PRELIMINARY DRAINAGE REPORT
for
THE COMMONS AT FALCON FIELD

El Paso County, Colorado

March 2024

PCD FILE NO. SP-232

OVERALL EXISTING DRAINAGE MAP
 PROJECT NO. 21604-00CSCV
 DRAWING NO.

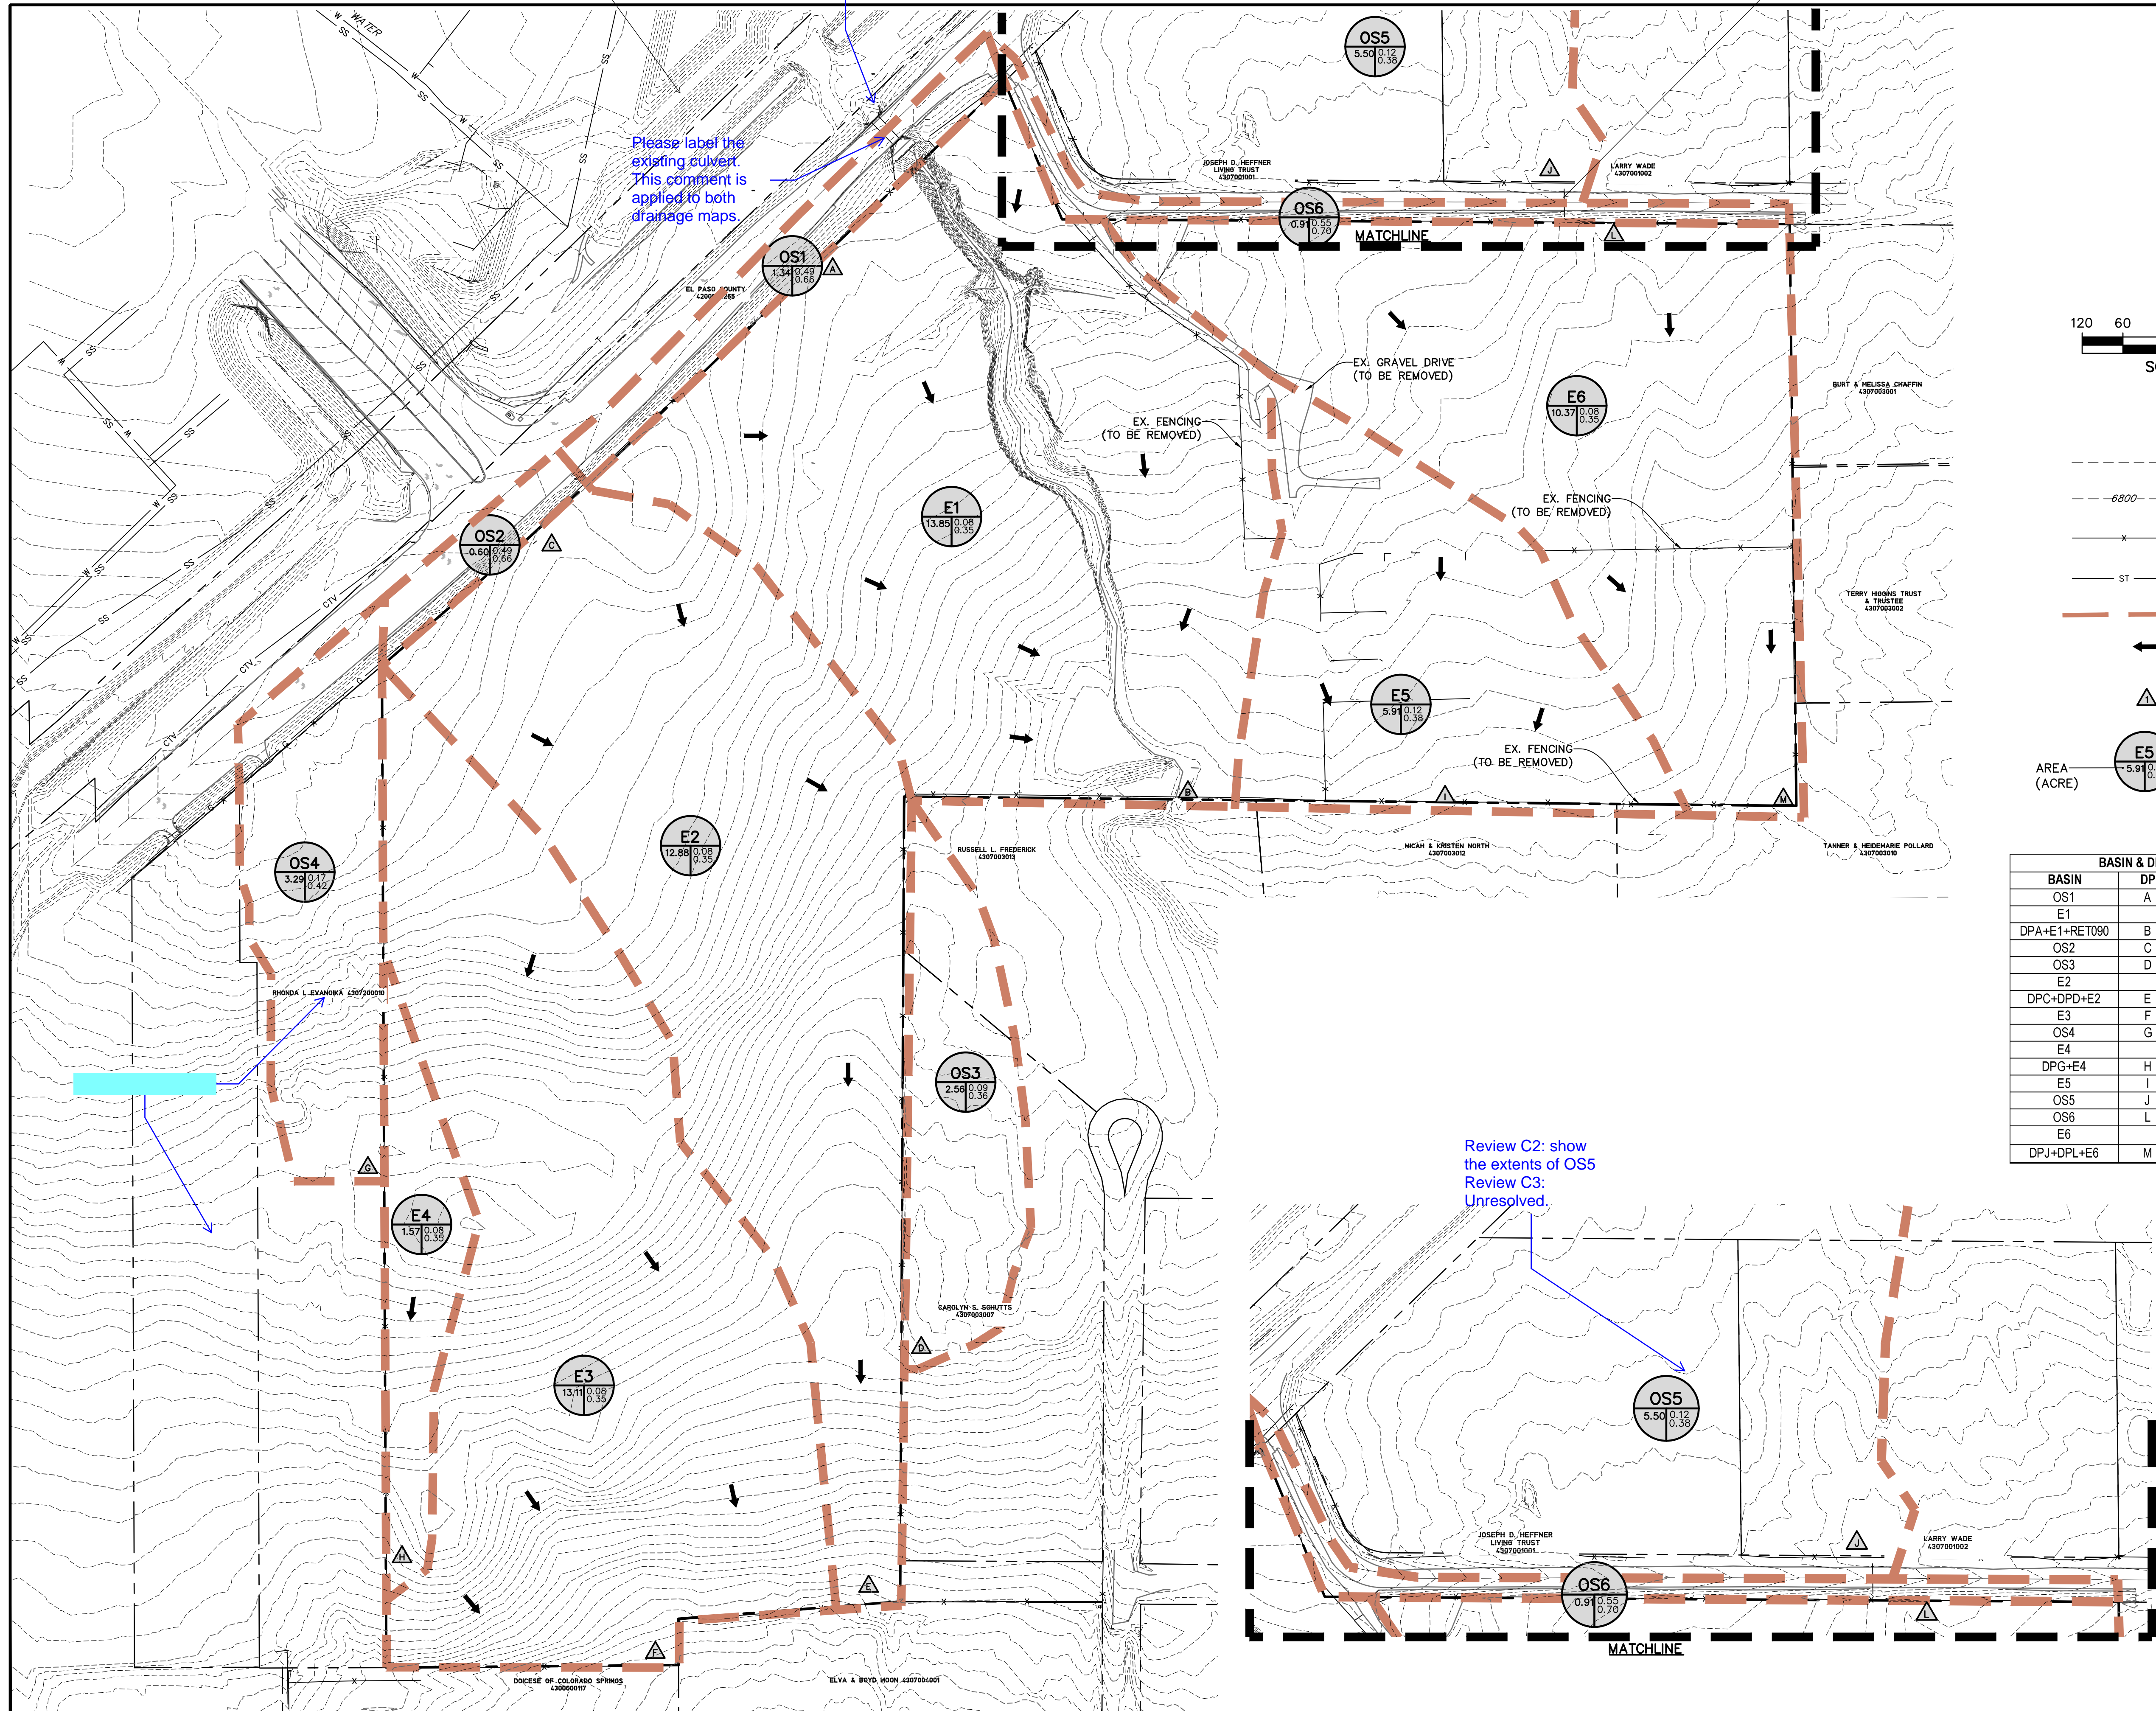
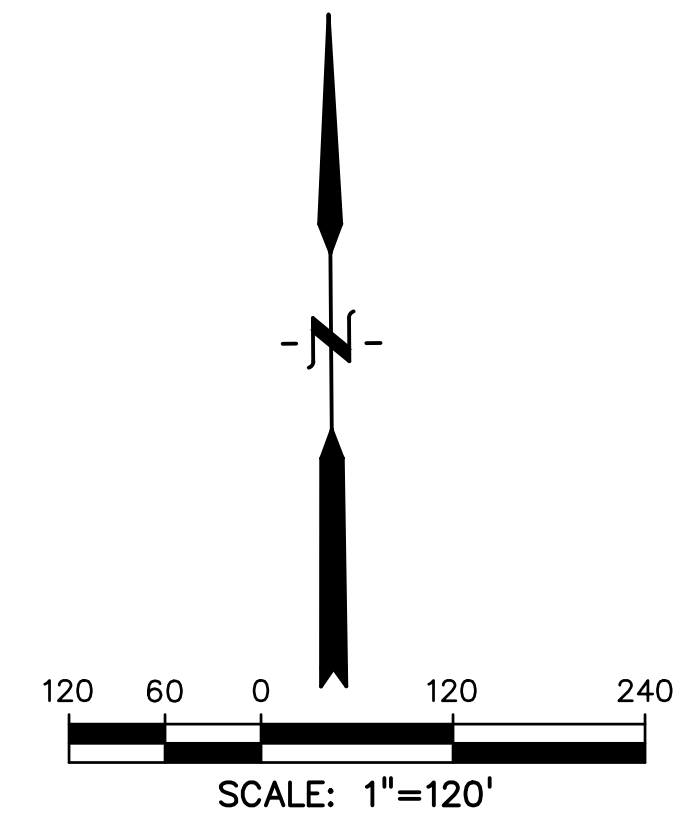
Review C2: identify the flow entering the site from the upstream through the existing culvert.
 Review C3: Unresolved. Please discuss off site flows that affect the subject project for both drainage conditions.

Please add off site flow directions, and elevation of contours.

Please show and label the existing roadside ditch and 18 inches CMP culvert discussed in basin OS 5, in the text.

Unresolved from Submittal 2: this should be included as an offsite basin

Please label the existing culvert. This comment is applied to both drainage maps

Review C2: show the extents of OS5
 Review C3: Unresolved.

All disturbance areas must be included within the drainage basin delineation. This comment is applied to all applicable drainage maps.

OVERLOT PROPOSED DRAINAGE MAP

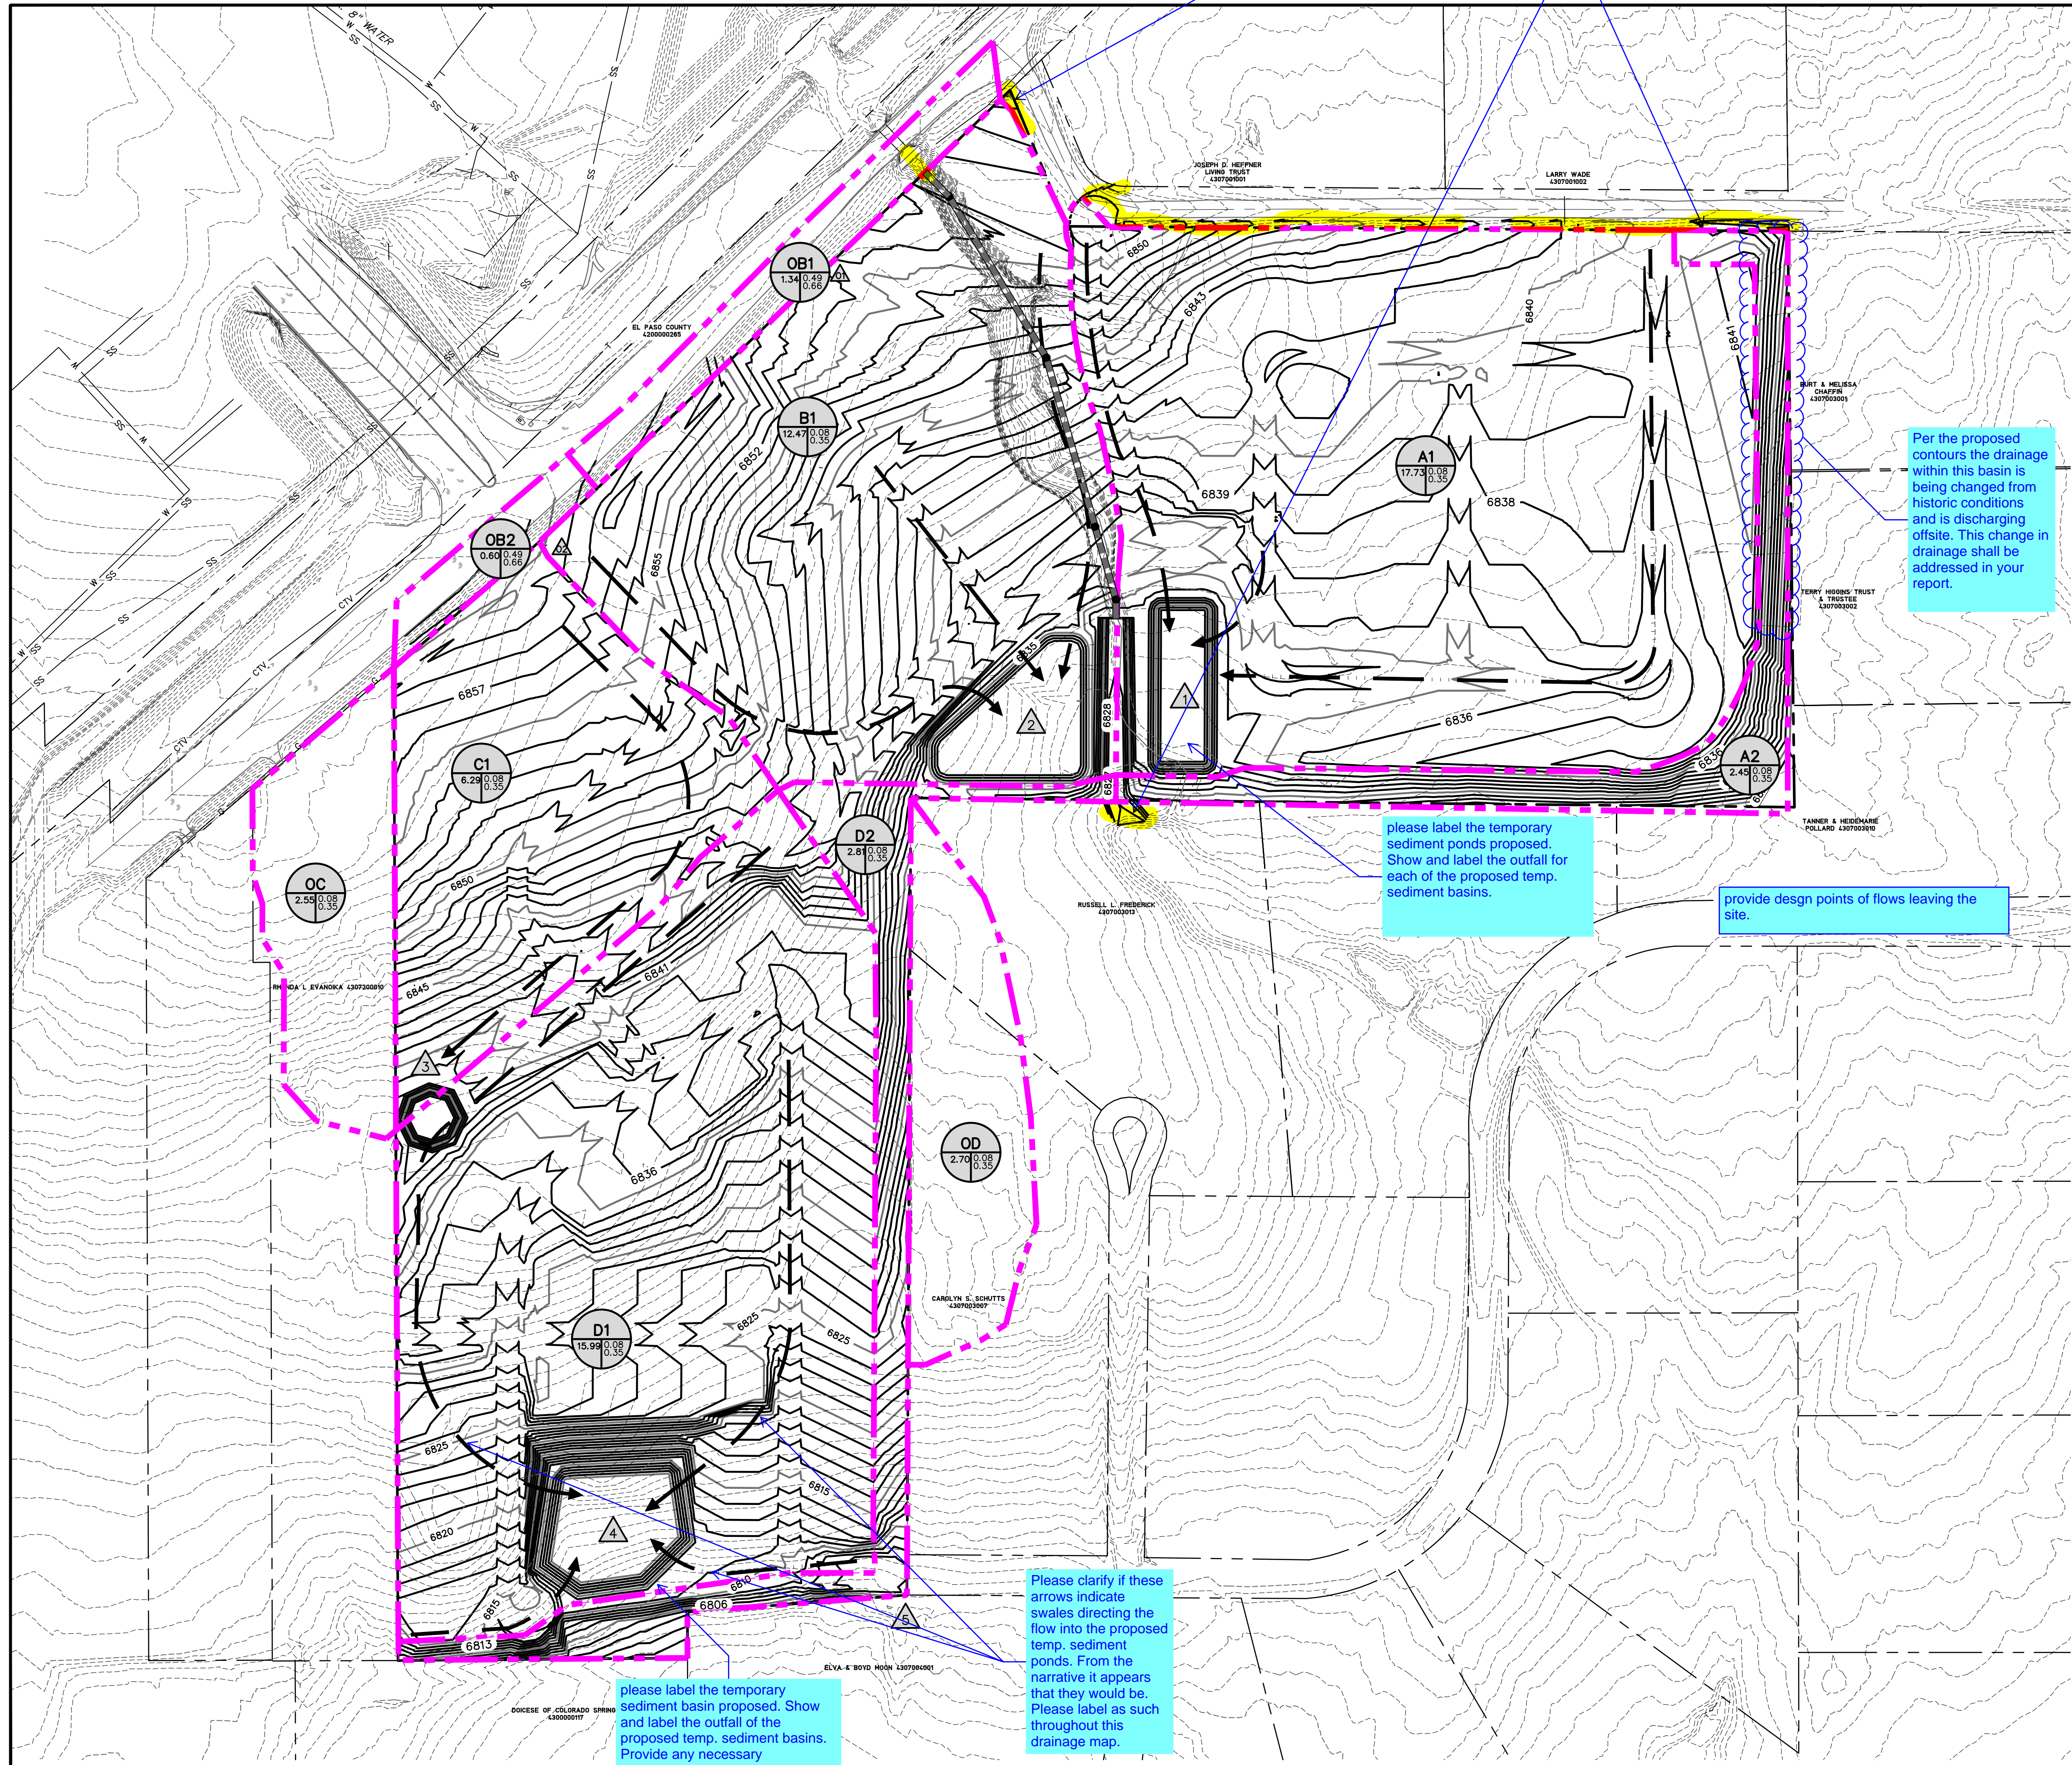
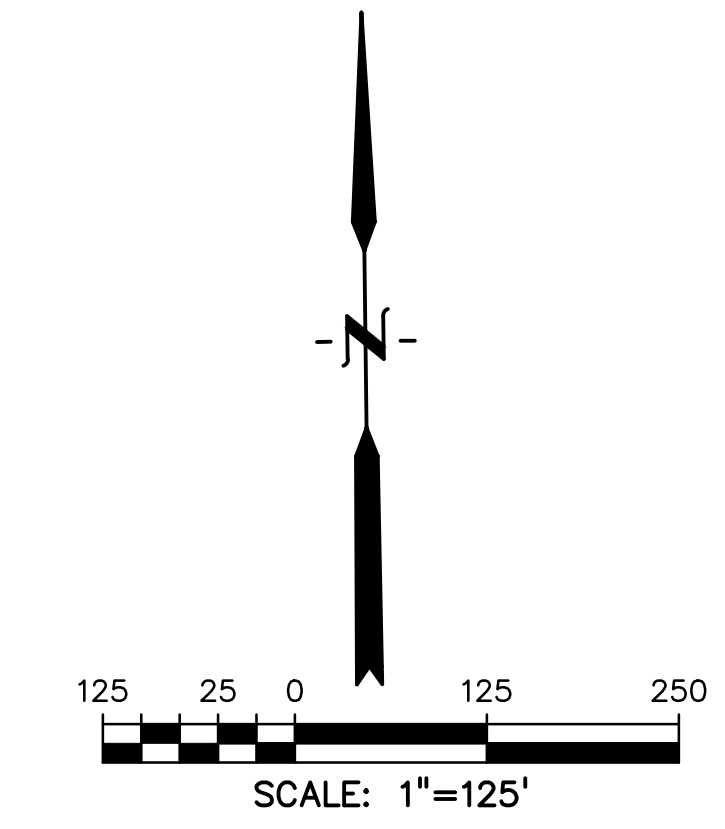
Per the proposed contours the drainage within this basin is being changed from historic conditions and is discharging offsite. This change in drainage shall be addressed in your report.

please label the temporary sediment ponds proposed. Show and label the outfall for each of the proposed temp. sediment basins.

provide design points of flows leaving the site.

please label the temporary sediment basin proposed. Show and label the outfall of the proposed temp. sediment basins. Provide any necessary downstream mitigation due to the concentrated flow at the outfall

Please clarify if these arrows indicate swales directing the flow into the proposed temp. sediment ponds. From the narrative it appears that they would be. Please label as such throughout this drainage map.
